Hocutt-Ellington Library Renovation

Bid # 700-ENG-2025-12

Addendum No. 02

E202

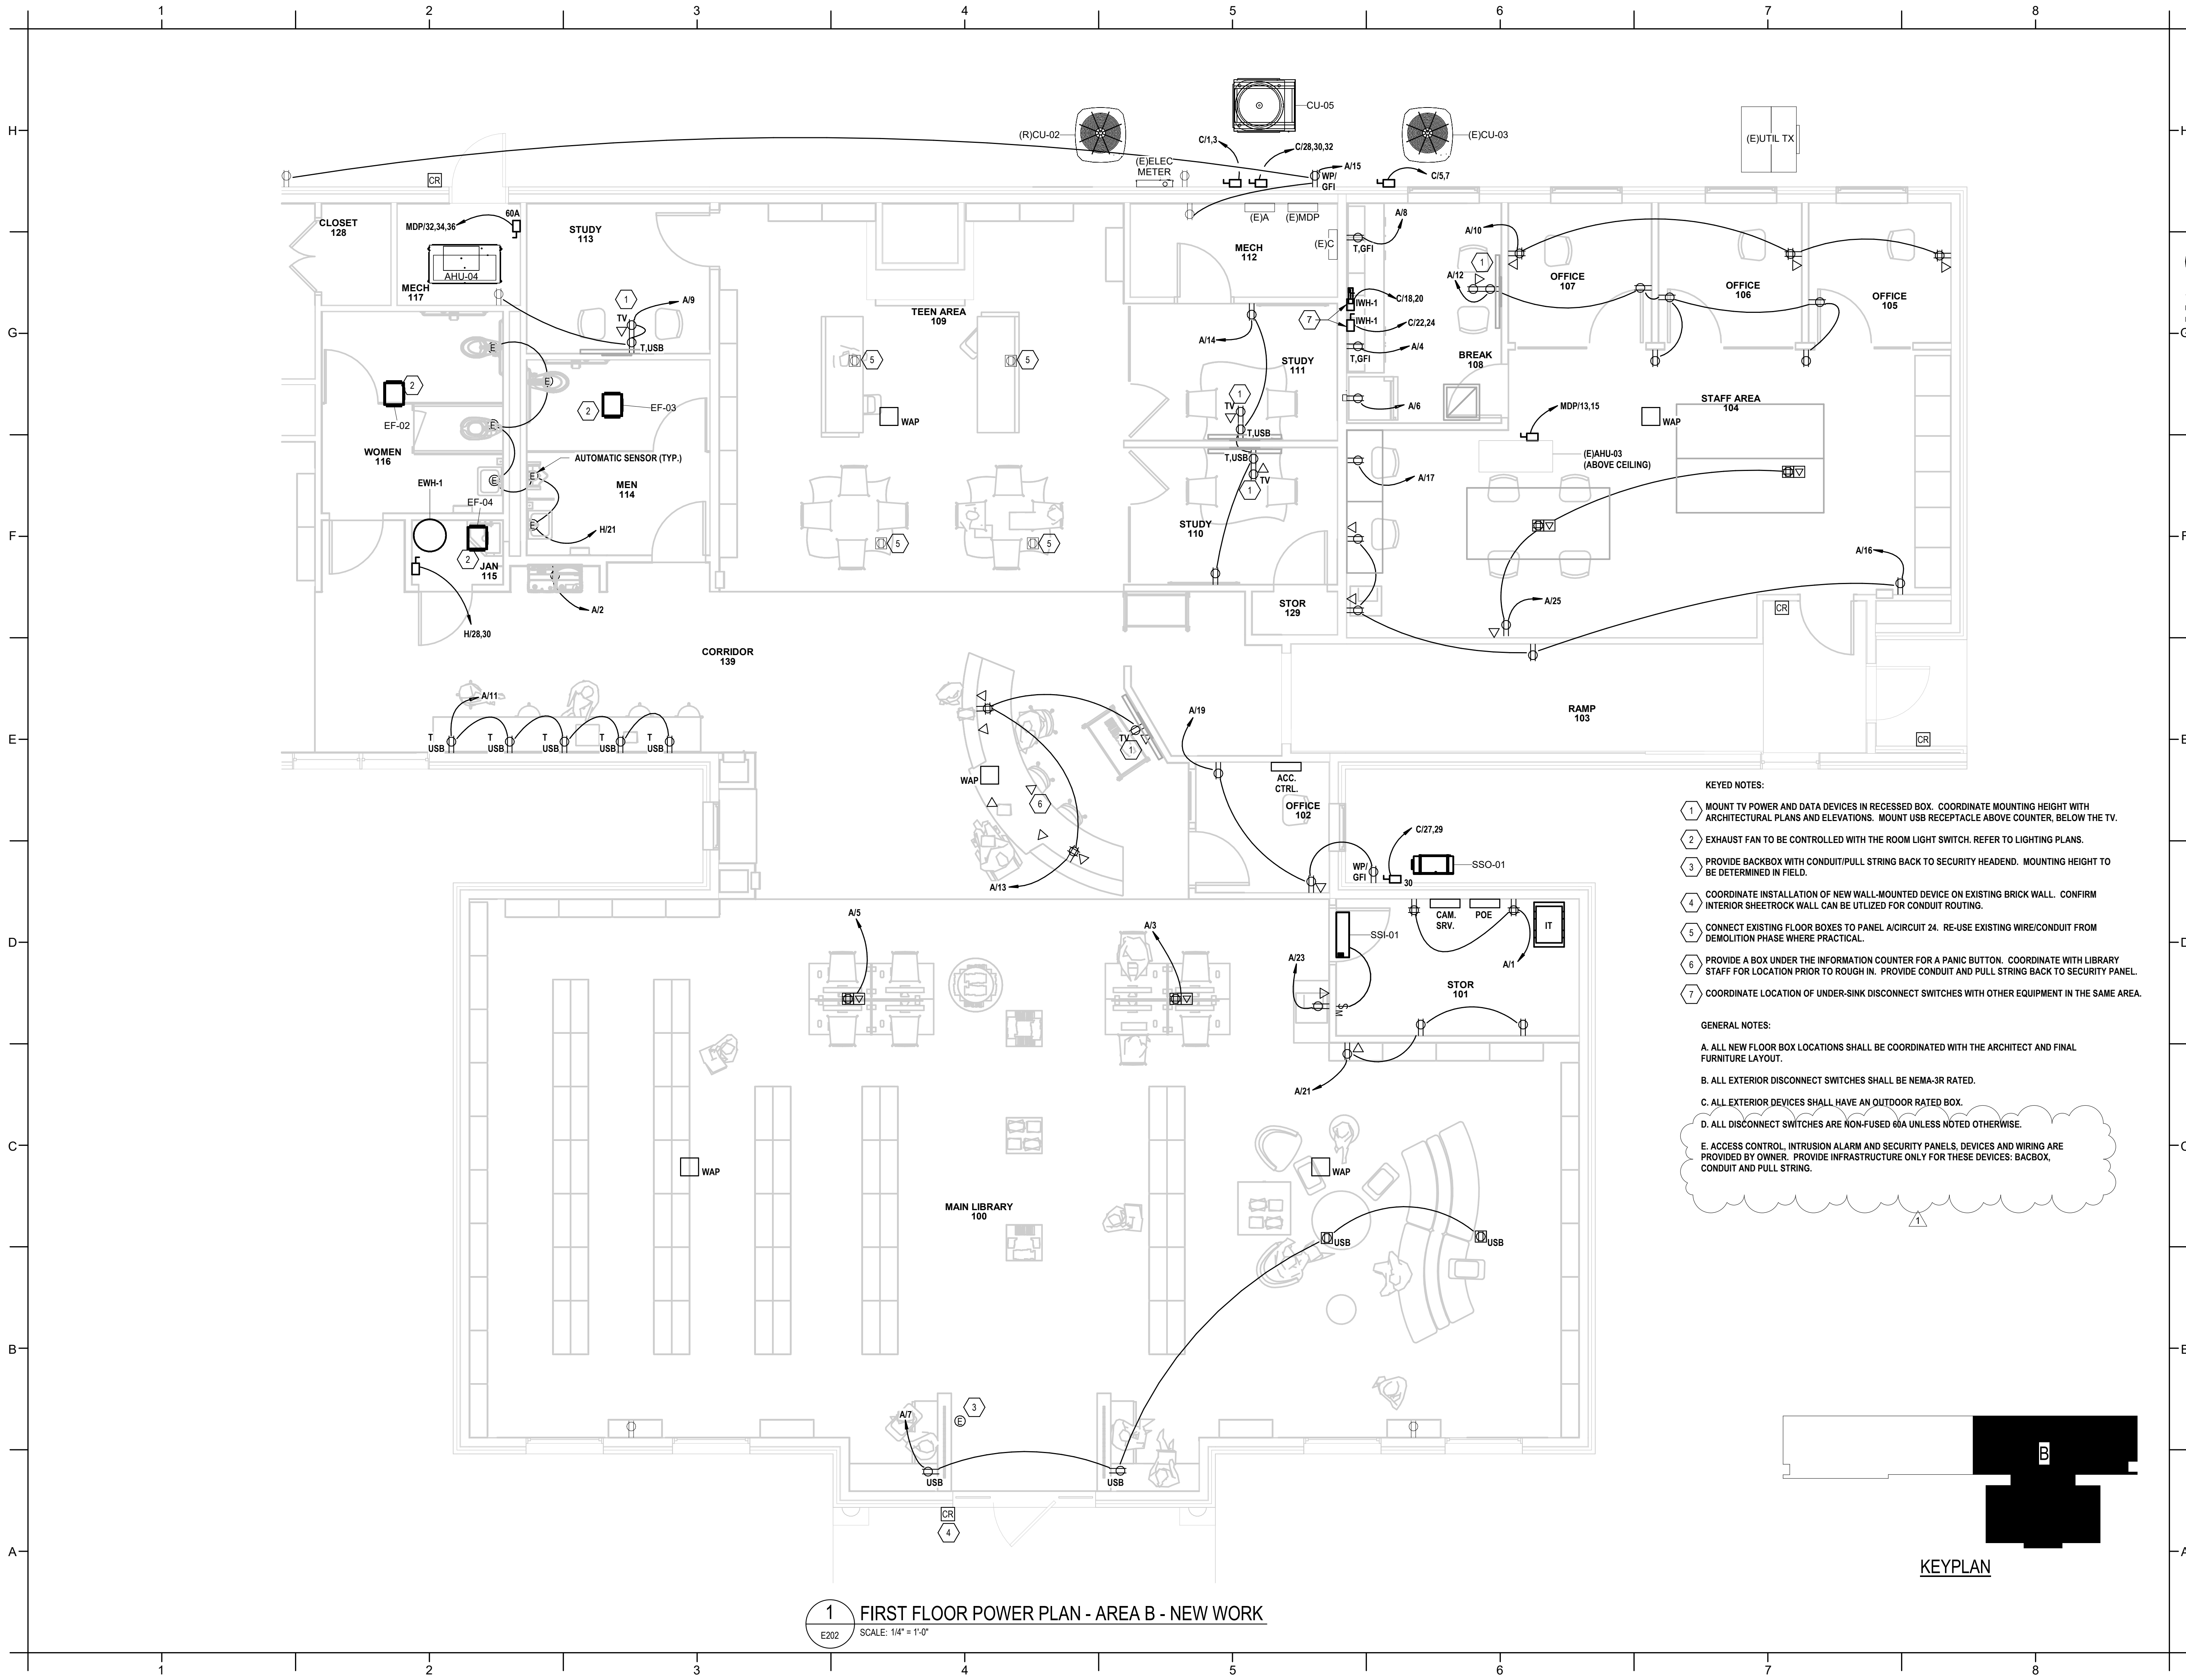
2. **Clarification: Regarding access controls, intrusion alarm, and security camera scope, all of the infrastructure for these scope items shall be in the GC's scope of work. But the new access controls, alarm, and security cameras, associated wiring, devices, face plates, etc. will be installed by the Owner's 3<sup>rd</sup> party vendor and the GC shall coordinate with them as part of their scheduling of construction activities. The electrical drawings and specs have been updated to communicate this intent for the GC to provide just the infrastructure.**

1. Sheet A400
  - a. Revised Restroom Elevations G4, G6, and A2 to remove the bullnose tile base (TB1) and instead indicate a metal transition trim.
2. Sheet A610
  - a. Added detail A6 to indicate the floor base treatment in restrooms for walls that do not have tile.
3. Sheet I100
  - a. Removed signage tag "ST-F" from the children's room area.
4. Sheet ED201
  - a. Clarifications for fire alarm system scope.
5. Sheet E201
  - a. Clarifications for access control, intrusion alarm and security panels, devices, and wiring.
6. Sheet E202
  - a. Clarifications for access control, intrusion alarm and security panels, devices, and wiring.

- A. ALL NEW FLOOR BOX LOCATIONS SHALL BE COORDINATED WITH THE ARCHITECT AND FINAL FURNITURE LAYOUT.
- B. ALL EXTERIOR DISCONNECT SWITCHES SHALL BE NEMA-3R RATED.
- C. ALL EXTERIOR DEVICES SHALL HAVE AN OUTDOOR RATED BOX.
- D. ALL DISCONNECT SWITCHES ARE NON-FUSED 80A UNLESS NOTED OTHERWISE.
- E. ACCESS CONTROL, INTRUSION ALARM AND SECURITY PANELS, DEVICES AND WIRING ARE PROVIDED BY OWNER. PROVIDE INFRASTRUCTURE ONLY FOR THESE DEVICES: BACKBOX, CONDUIT AND PULL STRING.
